**SUBJECT:** Safety Recall Campaign "XC";  
Daytime Running Light (DRL) Module Overheating

**MODEL(S):** Verona (RP625)

**Revision(s):** 12/3/14, Revision 1; This bulletin has been updated to include a second location that the DRL module can be found.

Above the DLC  
(Manual A/C Control)

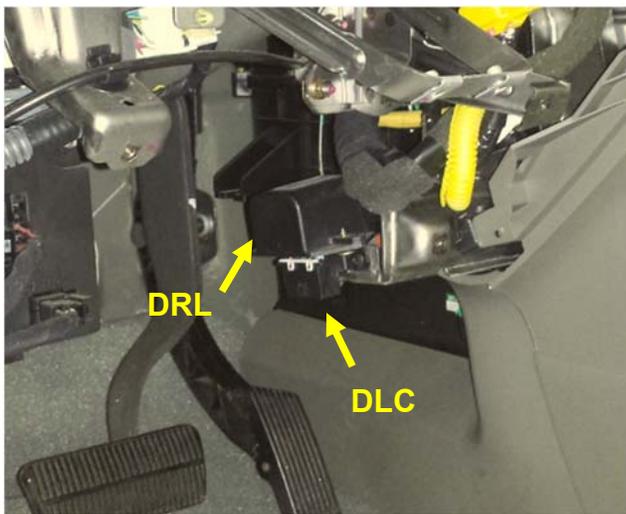
1. Record the radio presets then turn the ignition switch to the LOCK position and remove the key.
2. Disconnect the battery negative (-) cable and wait at least 90 seconds for the Supplemental Restraint System (SRS) to discharge before proceeding.
3. The location of the DRL module will be in one of two places:
  - a) With Auto A/C Controls: Behind the ash tray assembly and below the radio. Go to step 4.
  - or
  - b) With Manual A/C Controls: Above the Data Link Connector (DLC). Go to Step 9.
